TMI-09-107
November 9, 2009

Three Mile Island Nuclear Station, Unit 1
Renewed Facility Operating License No. DPR-50
NRC Docket No. 50-289

Subject: Response to Request for Additional Information Regarding Generic Letter 2004-02

Figure 9: LPI NPSH – EQ Reactor Building Response – Case IV (Hours)

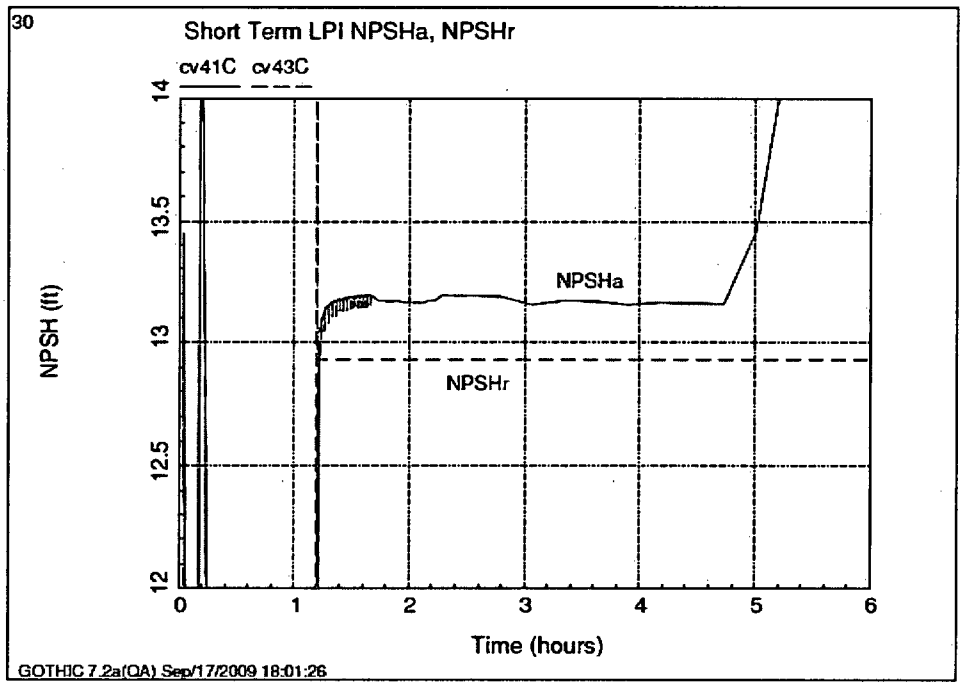
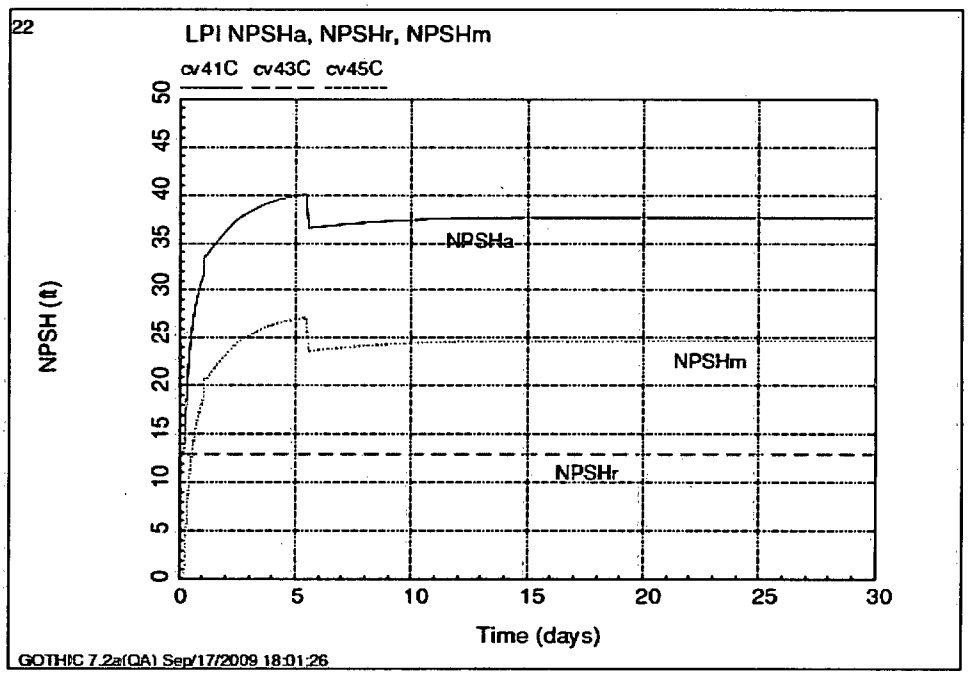
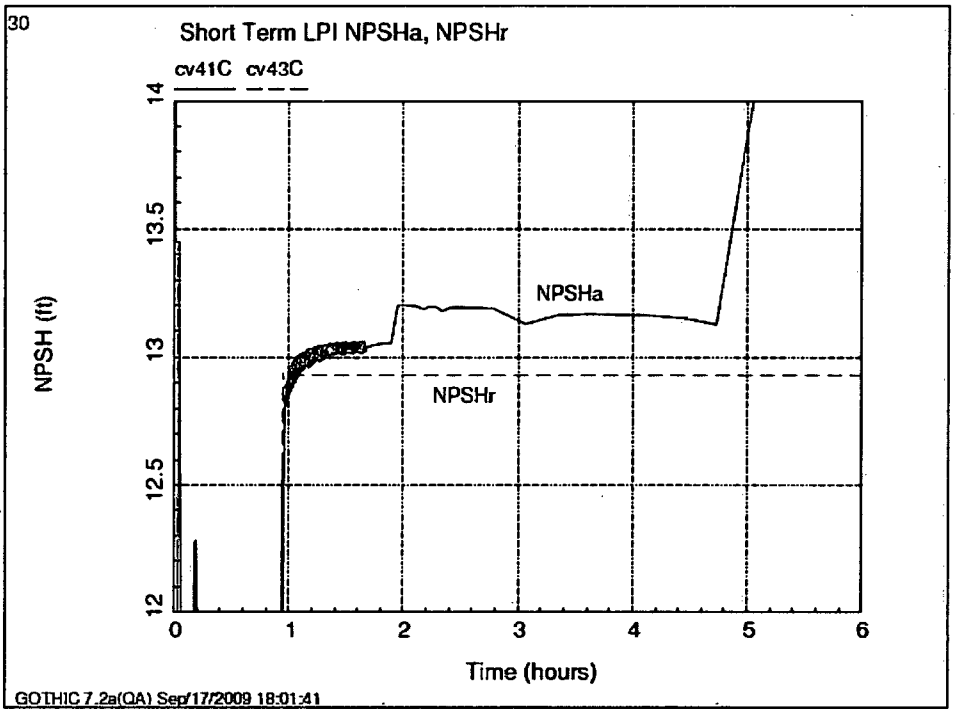
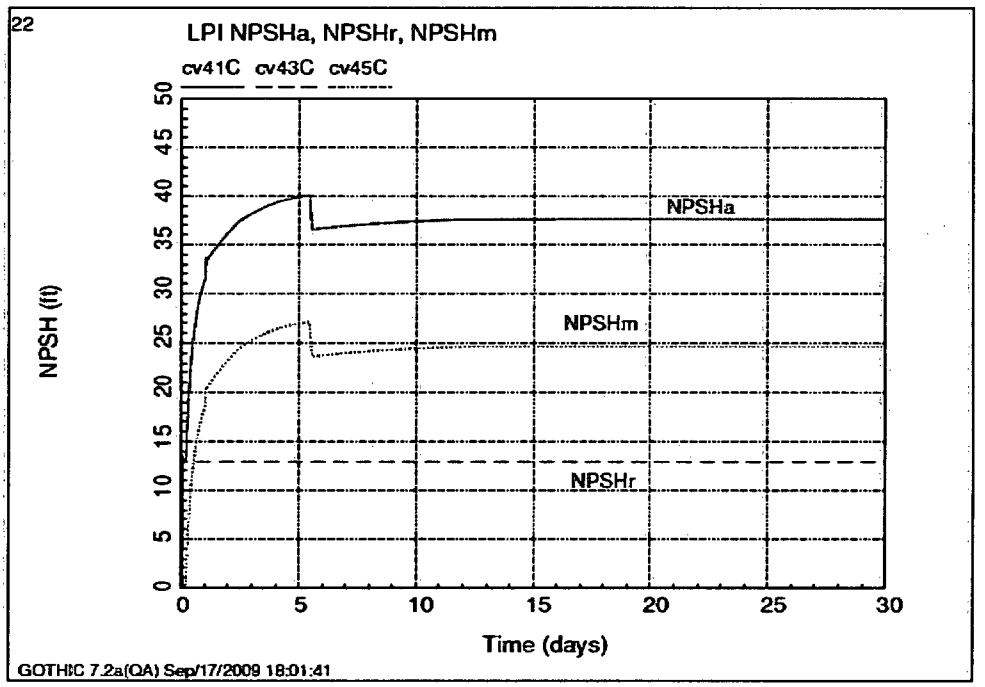
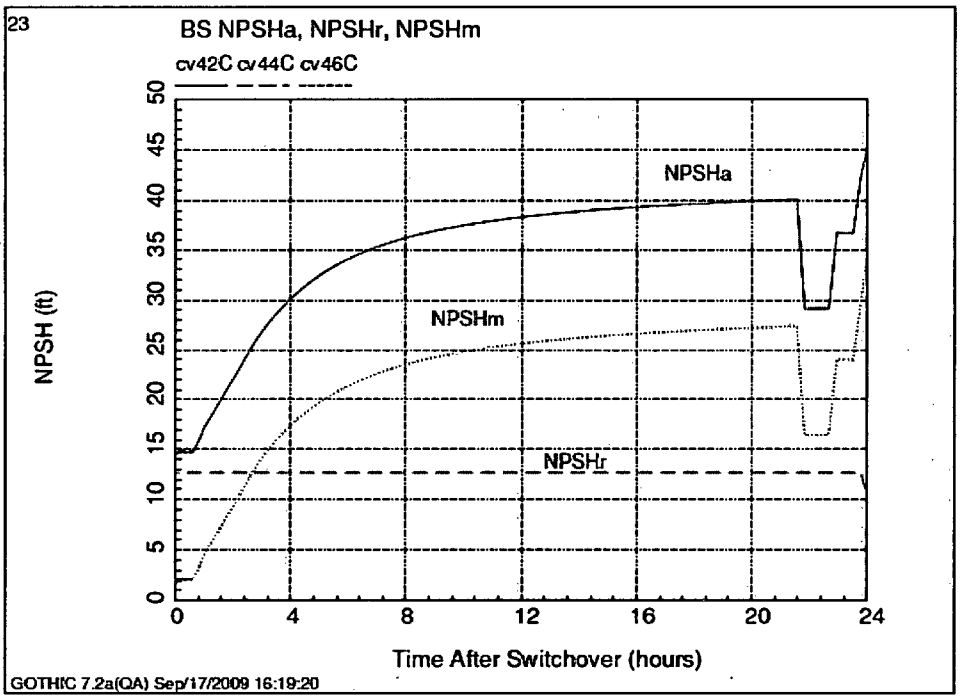
The staff requested that the licensee provide a more detailed description of the NPSH margin calculation methodology, including a description of the time-dependent analysis specifying selected values for NPSHa (NPSH available) and NPSHr (NPSH required) throughout the mission time. Although some information was provided in response to this request, the staff did not consider the response complete because sufficient information was not provided for the dependence of NPSHa on the sump pool water temperature as well as the time-dependence of the NPSH margin. While it is clear that the available margins are very small at the worst point in the limiting accident sequence (i.e., the minimum NPSH margin is 0.1 ft), it is unclear to the staff when this minimum margin occurs, how long it persists, and how much margin exists at other times during the accident. Therefore, to fully resolve this RAI, the staff is requesting that the licensee provide plots of NPSH margin versus time (or sump temperature if this parameter was used in lieu of time) for the limiting case (or cases) for both the LPI and building spray (BS) pumps that demonstrate the periods of minimum NPSH margin and the behavior of the NPSH margin as a function of time (or sump temperature).

The limiting case for LPI pump NPSH margin is EQ Case V (Table IX, Attachment 5). Short and long term NPSH plots for both Cases IV and V for the LPI pumps are provided.

The limiting case for BS pump NPSH margin is EQ Case I (Table X, Attachment 5).

Figure 14: LPI NPSH – EQ Reactor Building Response – Case IV (Hours)

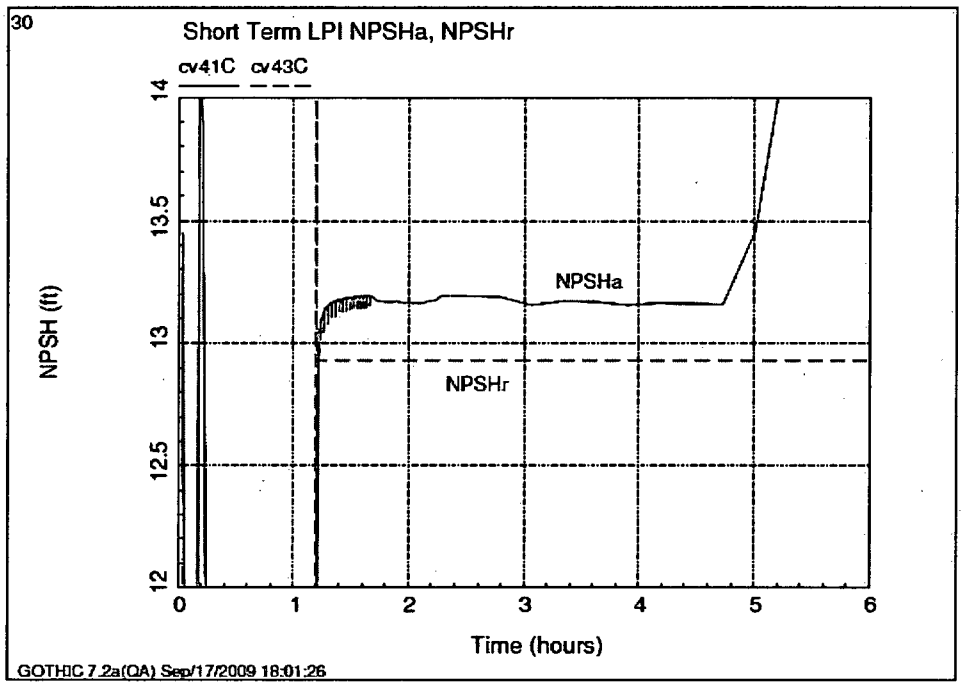
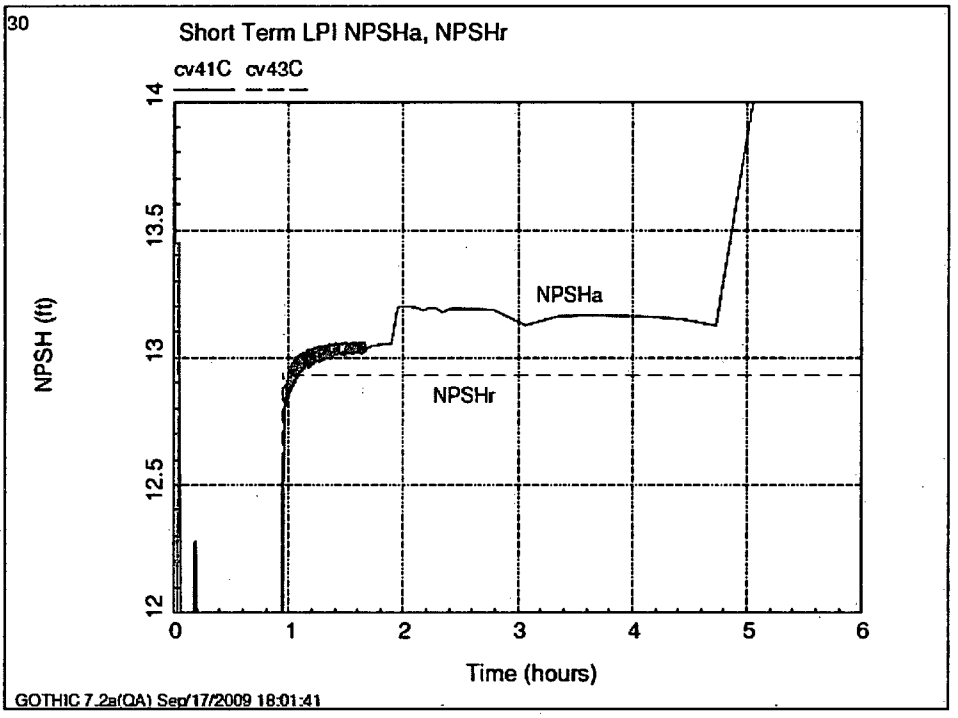
The staff requested that the licensee provide a discussion of how the single failure criterion was used in determining the bounding NPSH margin and why there is confidence that the worst-case single failure was identified and considered. The licensee's response to this item described a single failure of an LPI pump as being the worst-case single failure. Upon considering the NPSH margin results in Table 14 in the supplemental response, as well as the response to RAI 17 that indicates that maximizing reactor building cooling is considered a limiting condition, the staff questioned whether a configuration with one operating LPI pump and two operating BS pumps would be bounded by the results presented. For the case of two operating LPI pumps, having two operating BS pumps led to the minimum NPSH margin, but a corresponding case was not analyzed for single-train LPI operation. Please either (1) provide a basis for considering the configuration of one LPI pump and 2 BS pumps operating to be bounded by the cases analyzed or (2) provide a basis for concluding that this operating configuration will not be implemented following a LOCA (e.g., it would not be allowed by emergency procedures).

The TMI, Unit 1 NPSH Margin Analysis has been revised to add the additional case of a single LPI pump operating with both of the BS pumps operating. The minimum NPSH margin for this Case (Case V) was slightly lower than for Case IV as shown in the plots below. However, the minimum NPSH margin remains at 0.1 ft.

A graph of NPSHa and NPSHr versus time for the first six hours of operation in the recirculation mode for EQ Case IV is provided below. The minimum margin for this case was listed as 0.1 ft in Table 14 (Reference 1). When the scale of the plot was expanded and compared to the result for Case V, it is evident that the NPSH margin for Case IV is initially slightly greater than the margin for Case V. The minimum margin for Case IV provided in the revised Table 14 (Attachment 5) is 0.2 ft based on the stable NPSH margin that exists after recirculation conditions are established.

A graph of NPSHa and NPSHr versus time for the first six hours of operation in the recirculation mode for EQ Case V is provided below. The minimum stable NPSH margin for the first hour of operation is 0.1 ft. After 1 hour, the first BS pump is secured as described in the previous response to Issue 3f.10 (Reference 1). After the first BS pump is secured, the configuration is then equivalent to Case IV and the margin increases to 0.2 ft.
